ADDENDUM No. 1

RFP No. 24-51

Leslie Park and Sylvan Park Bridge Replacements

Drawing No.
C-100

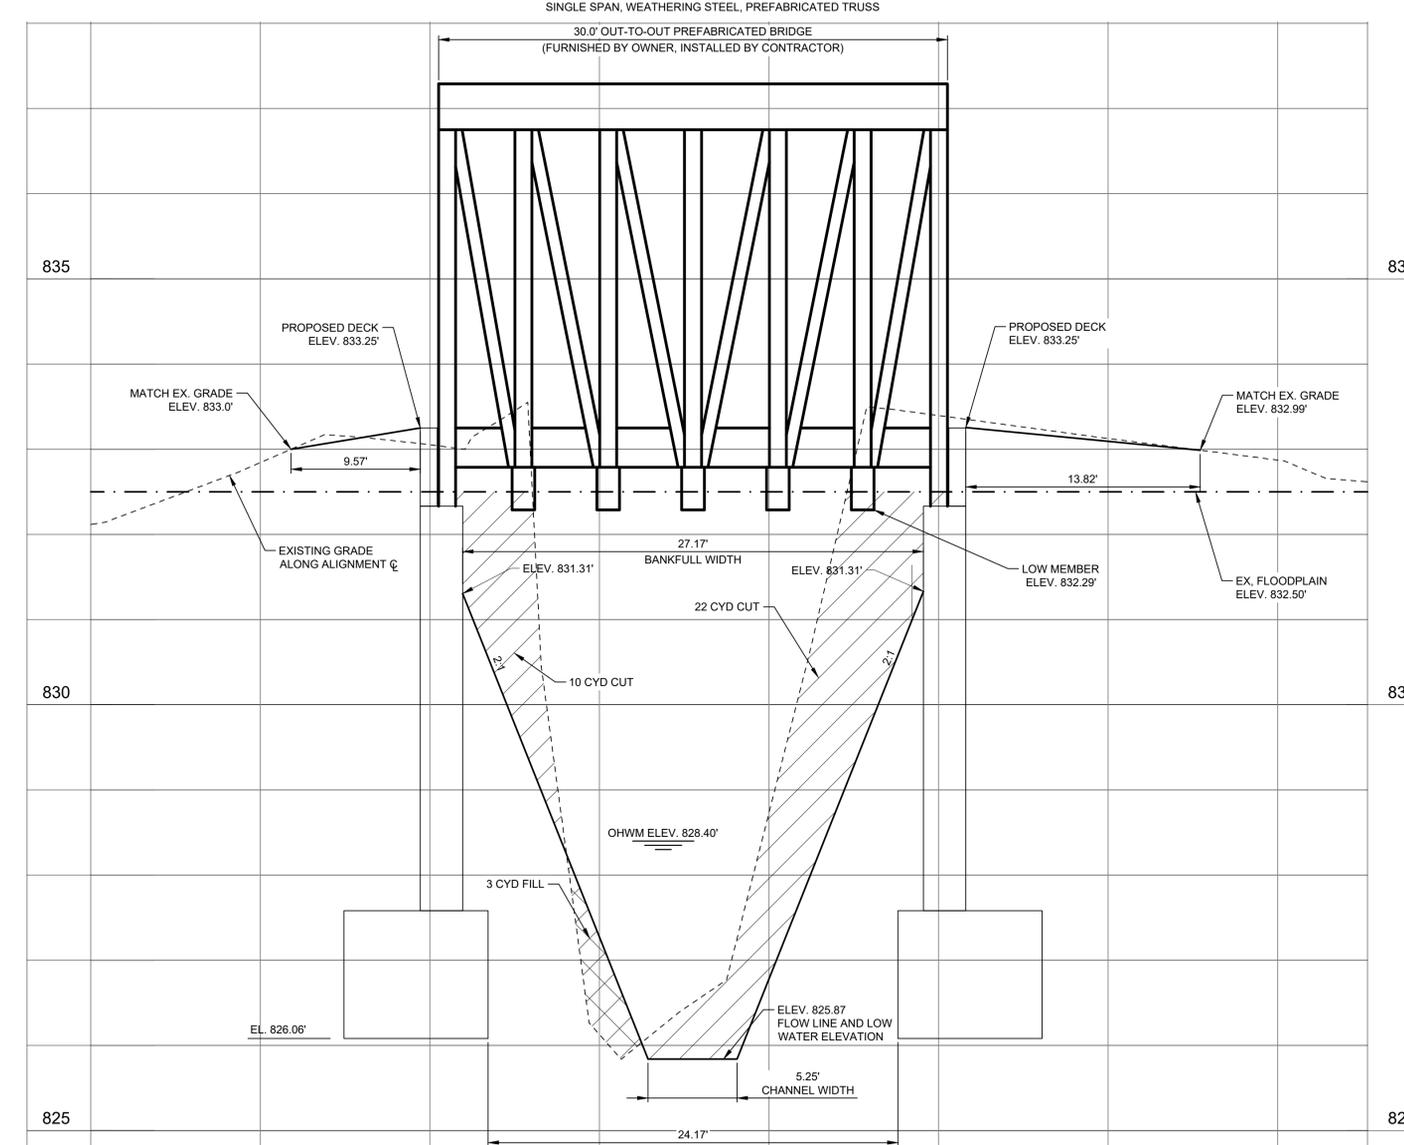
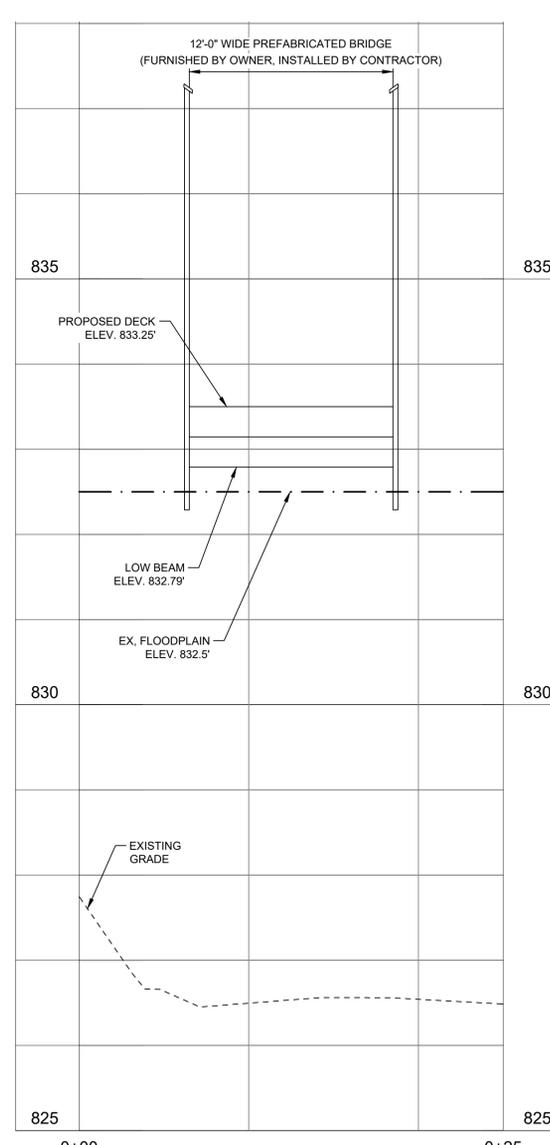
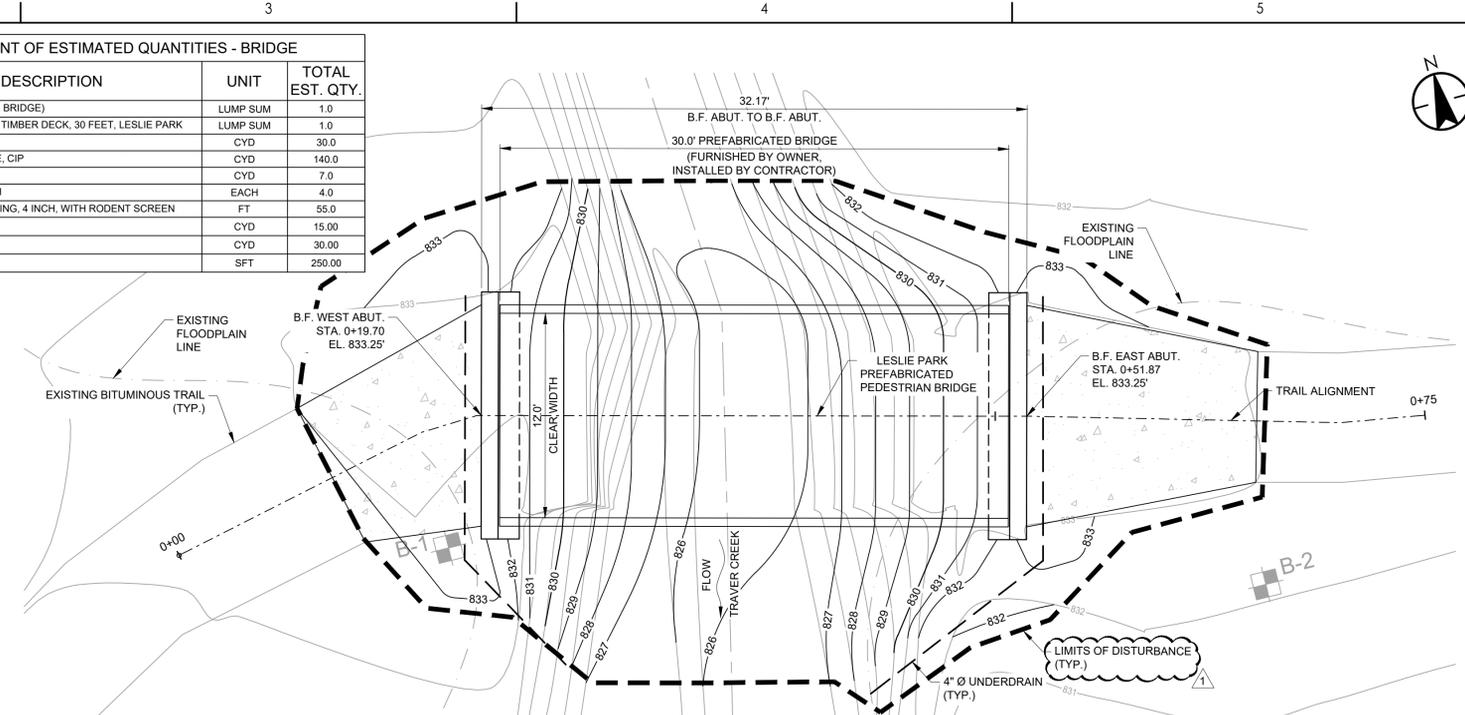
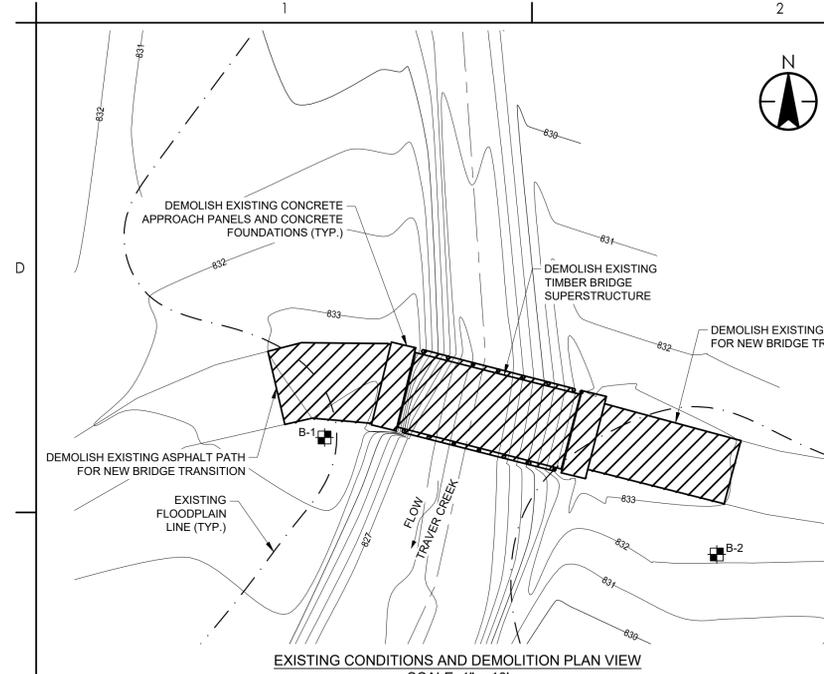
Section/Page(s)	Change
Drawing C-100	Added grading limits.
Drawings C-101 and C-102	Changed in its entirety per Contech's request.
Drawing C-103	Added callout to Section A-A
Drawing C-104	Added grading limits. The east-side of Sylvan Bridge is shown as being replaced with Sidwalk, Conc, 4 inch and quantity has been adjusted.
Drawing C-105	Added callout to Section A-A and Section B-B
Drawing C-200	Added sheet to provide staging plan.

Answer 1: Erosion Control, Silt Fence shall be placed at the grading limits (added to the plans for clarification) of the project. The Contractor is responsible for obtaining a SESC permit from the City of Ann Arbor. Any silt fence installed over the estimated quantity of 500 feet will be compensated.

Project No. 2075153906	Scale: AS NOTED
Revision Sheet 0 08 of 10	Drawing No. C-104

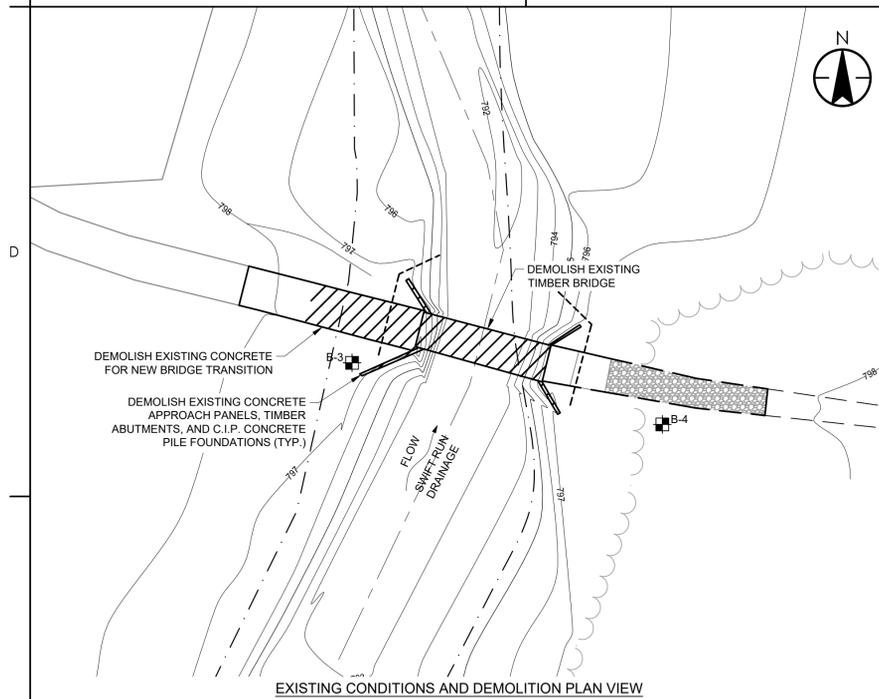
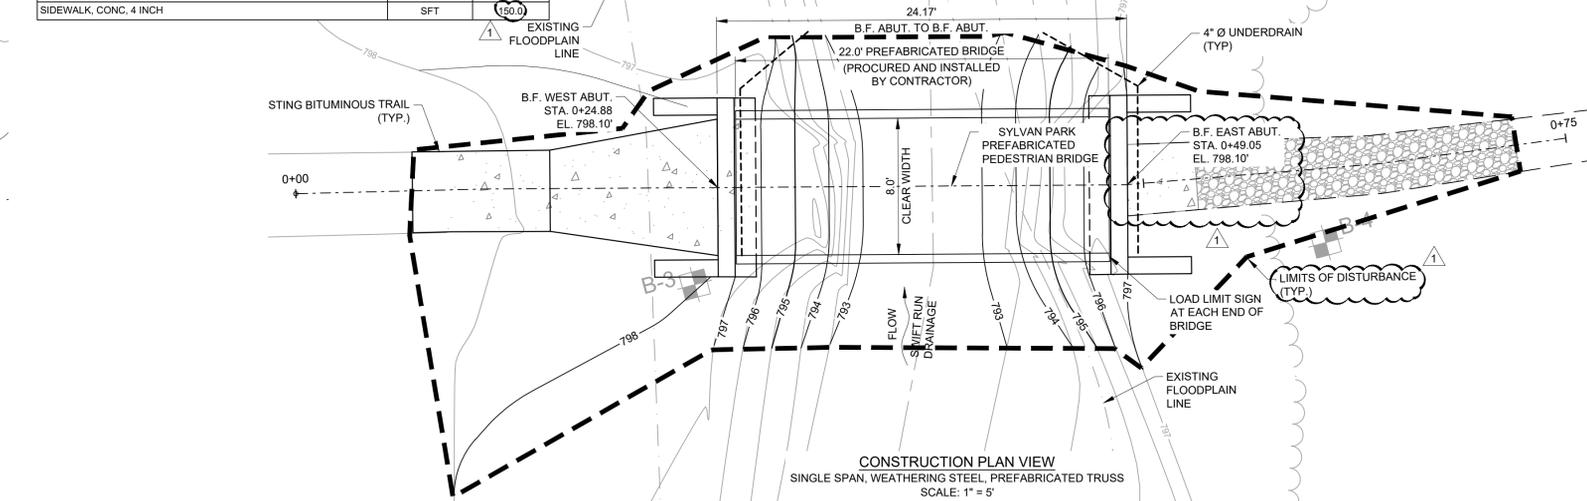
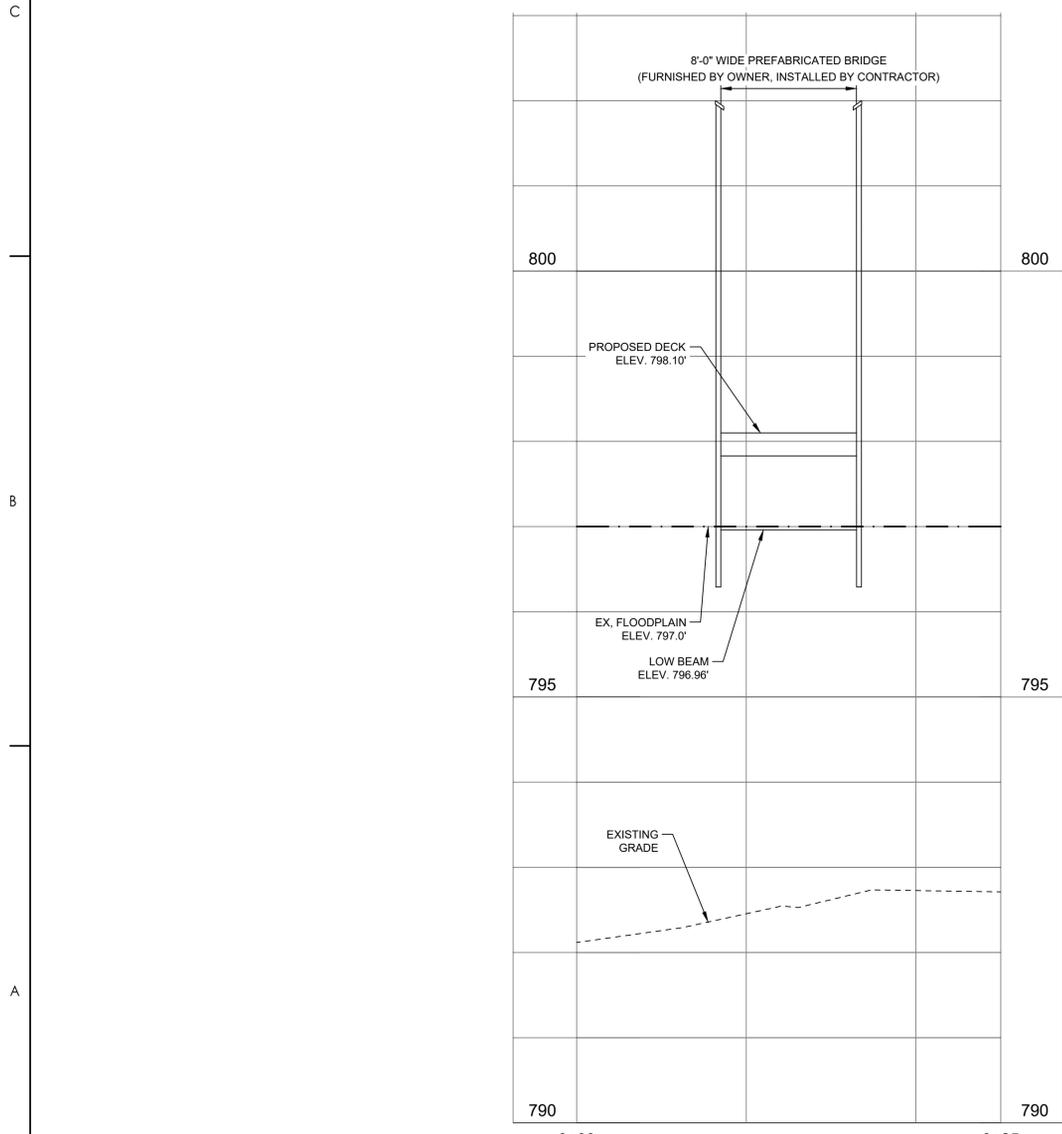
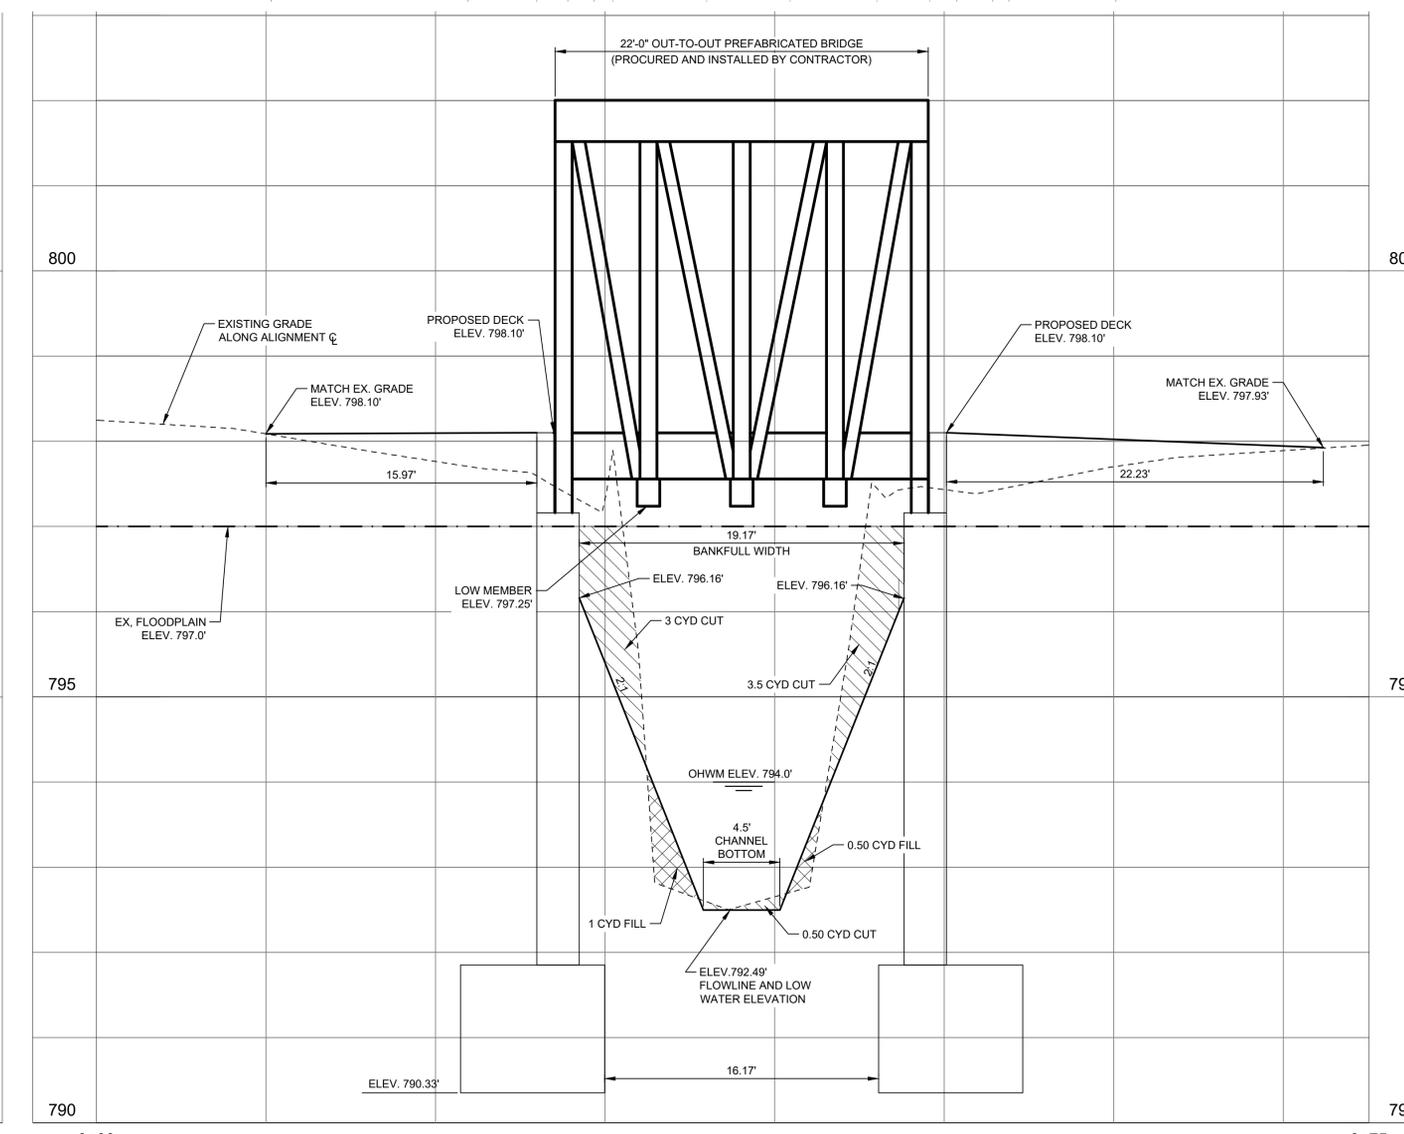
- Question 11: The plans appear to depict an aggregate surface course for the path on the east side of the bridge at the Sylvan Park location. Where is payment for the restoration of the path on this side of the bridge to be made?

- Answer 11: Drawing C-104 has been revised to show the east side of Sylvan Park bridge being replaced with sidewalk, paid for as Sidewalk, Conc, 4 inch. The quantity for this item has been increased to 150 sft.
